REQUEST FOR INFORMATION

RFI NUMBER	JDS-RFI-005			
ISSUE DATE (YY/MM/DD)	February 23, 2011			
PRIORITY	H	M	L	
REQ'D RESPONSE DATE	March 2, 2011

Hope Bay Mining Project

Subject:	Ground Temperature Cable Extensions	Project Zone/Area:	Doris North
Company:	SRK Consulting (Canada) Inc.	Station/Location:	North Dam
Attention:	Lowell Wade	Discipline:	Civil

Ground Temperature Cable Clusters

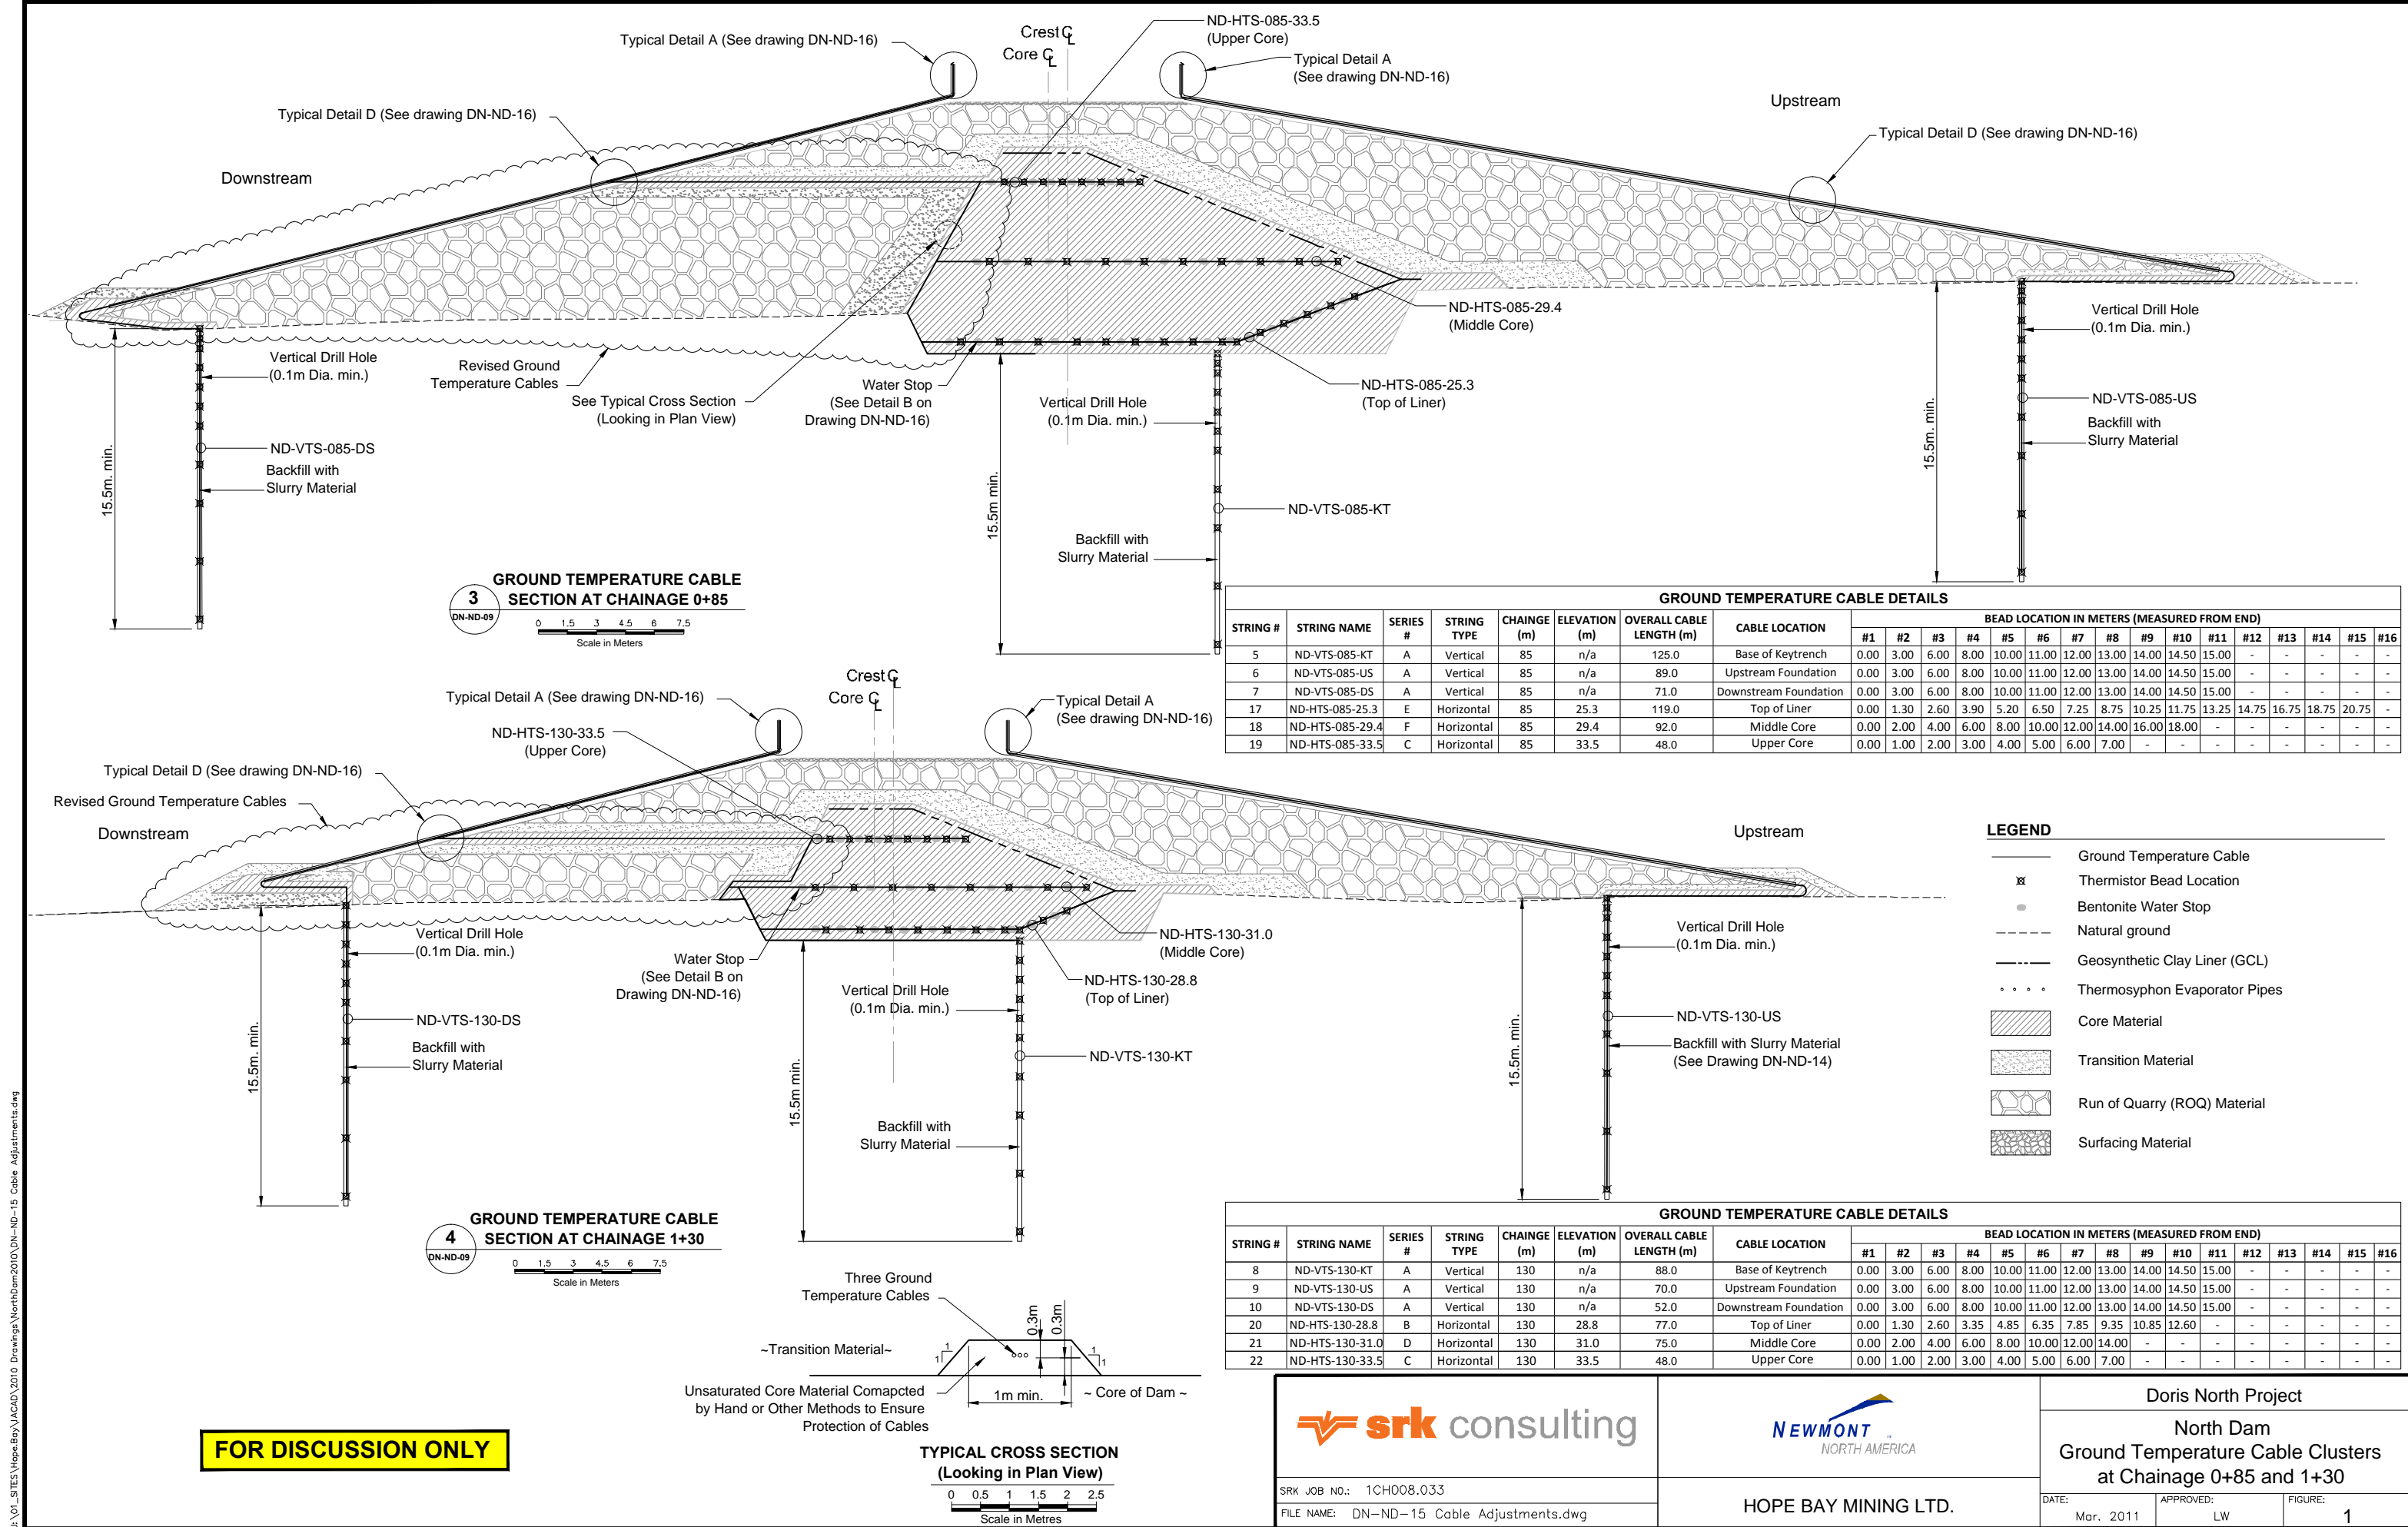
Please assess the implications of routing the ground temperature cables leads from the vertical cables installed in the base of the key trench, and the lower and middle layer horizontal cables along the downstream side of the core and then run through a common suite location (i.e. Sta. 0+40, 0+60, 0+85, 0+130, and 1+75) along with the upper layer of horizontal cables. The cable leads will be protected during construction in a similar manner as when the leads run up the downstream wall of the key trench.

Please assess the materials and dimensions that illustrates the cross section (Dwg. DN-ND-09) in which the cable extensions will be buried in the horizontal plane to extend to the downstream slope of the dam.

Route cable extensions from ground temperature cables in and beneath the core along the downstream side of the core and extend through a common suite location (i.e. Sta. 0+40, 0+60, 0+85, 0+130, and 1+75) along with the upper layer of horizontal cables. Please refer to the sketch attached.

Reduce x, y, z dimensions of 20 mm and transition material zone within which the cables extensions will be placed.

Response:			
SRK does not see an issue with the re-routing if the ground temperature cables as proposed. RST [the supplier of the ground temperature cables] confirmed the increased number of bends will not be an issue as the cable is constructed of multi-strand copper wire. Care should be taken so cable is installed with smooth bends. As the new cable routing will be along the outer edge of the Dam's core the cables will have to be protected from the ROQ shell by placing unsaturated compacted core material around the cables as the ROQ shell is being constructed. This is shown in the attached figure.			
Responsible Newmont Representative:	Lowell Wade	Sign:	March 29, 2011
	Print:		Date:
